WILLIS & CROSS ROAD SUBDIVISION

APPLICATION NUMBER 18 DATE July 11, 2013

REQUEST Subdivision

DETAIL SITE PLAN

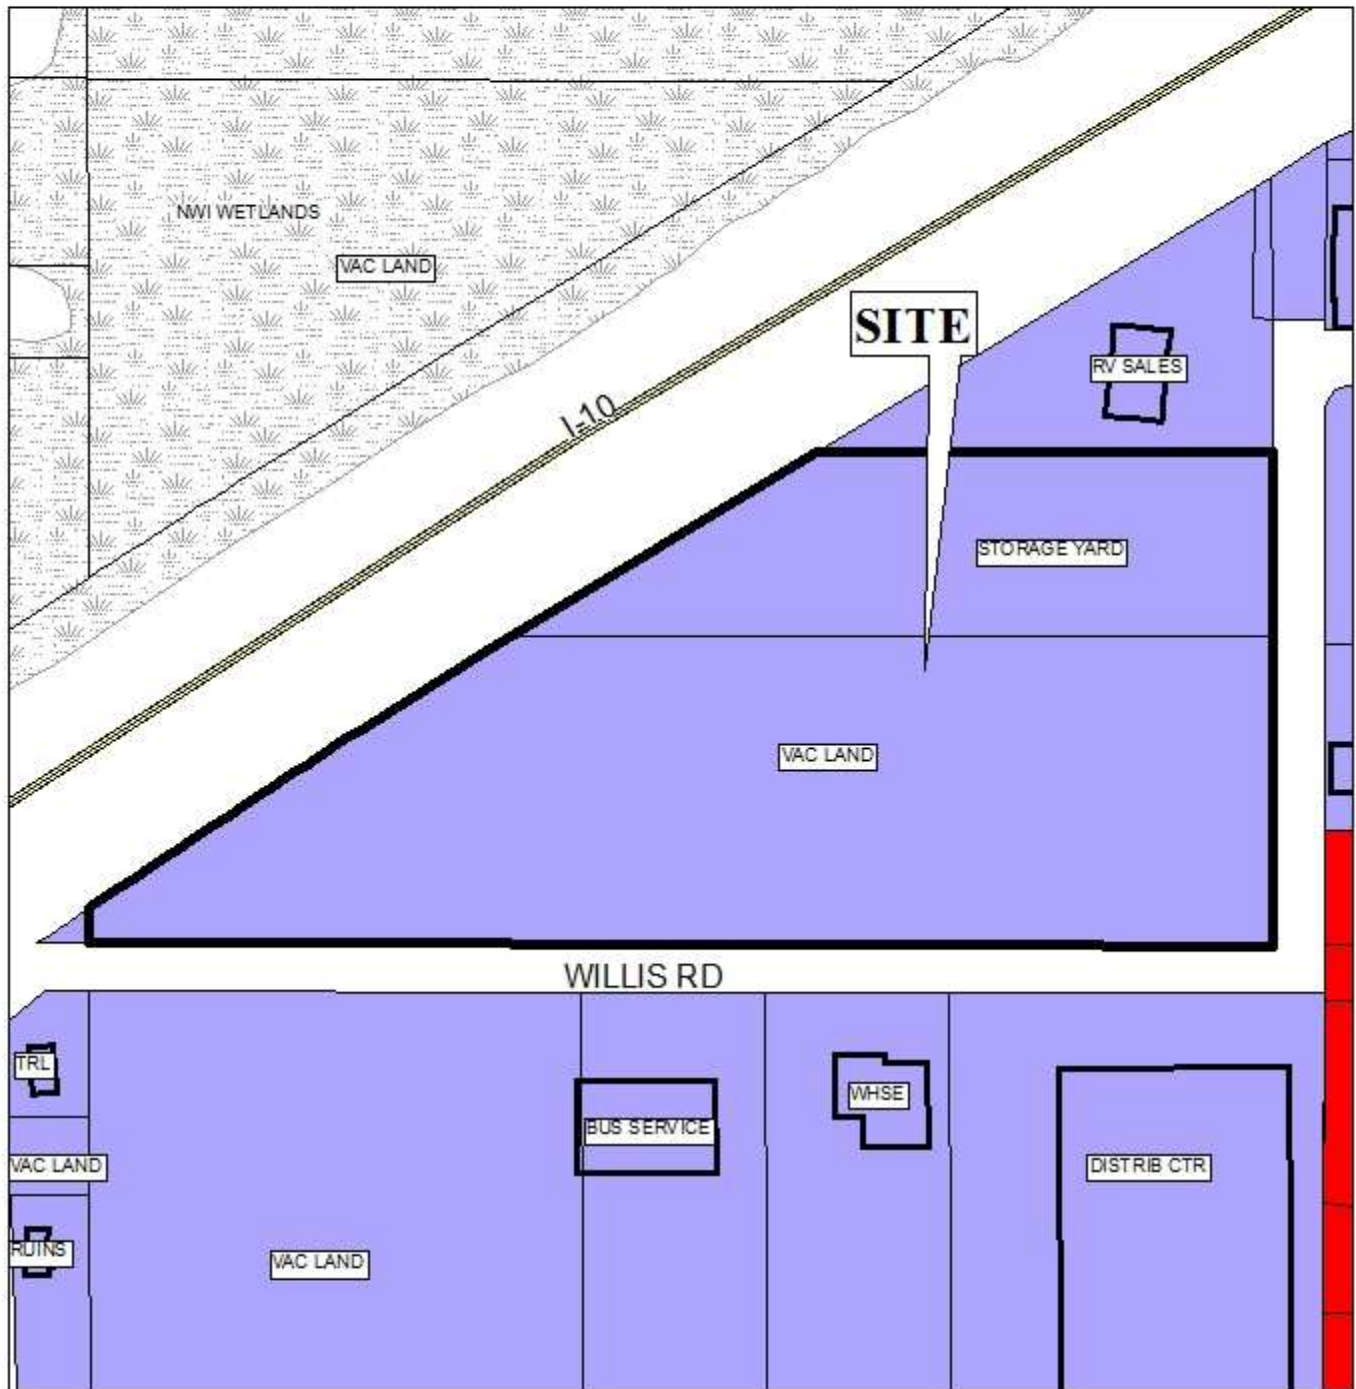
The site has frontage onto 3 streets, Interstate 10 (I-10) (936' \pm), Cross Road (1,277' \pm), and Willis Road (539' \pm). The 25' minimum setback for all frontages is depicted on the plat. The required right-of-way I-10 is 350': The site depicts right of way as 300' and not the required 350'. However, the additional 25' of right-of-way dedication is depicted along the I-10 corridor. Cross Road and Willis Road are minor streets with adequate ROW; however the corner of Cross Road and Willis Road does not depict appropriate curb radii or setbacks.

Access management is a concern due to the site abutting Interstate 10 and multiple street frontages. All lots should be denied access to Interstate 10. All lots should be limited to one (1) curb-cut each, with the size, design and location of all curb-cuts to be approved by Traffic

Engineering and conform to AASHTO standards. Lot 4, a corner lot, is limited to one-curb cut to one street (Willis Road or Cross Road) per Traffic Engineering comments.

- 1) placement of a note on the final plat stating that all lots are denied access to Interstate 10;
- 2) placement of a note on the final plat stating that all lots are limited to one (1) curb-cut each with the size, design and location of all curb-cuts to be approved by Traffic Engineering and conform to AASHTO standards.

- 3) dedication of 25 foot of right-of-way along the entire frontage of I-10, as depicted on the preliminary plat;
- 4) provide appropriate radii at the corner of Cross Road and Willis road as determined by Traffic Engineering;

- 5) retain 25' setback along all frontages;
- 6) provision of the required setback from radius dedication;
- 1) compliance with Engineering comments (*The following comments should be addressed prior to review, acceptance and signature by the City Engineer: 1. Provide all of the required information on the Final Plat (i.e. signature blocks, signatures, certification statements, legal description, required notes). 2. Add a note to the Plat stating that storm water detention will be required for any future addition(s) and/or land disturbing activity in accordance with the Storm Water Management and Flood Control Ordinance (Mobile City Code, Chapter 17, Ordinance #65-007 & #65-045). 3. Add a note to the plat stating that any work performed in the existing ROW (right-of-way) such as driveways, sidewalks, utility connections, grading, drainage, irrigation, or landscaping will require a ROW permit from the City of Mobile Engineering Department (208-6070) and must comply with the City of Mobile Right-of-Way Construction and Administration Ordinance (Mobile City Code, Chapter 57, Article VIII). 4. Dedicate a 50' radius (minimum) at the southeast corner of Lot 4 to Public ROW. Location and size to be approved by Traffic Engineer and City Engineer.*)
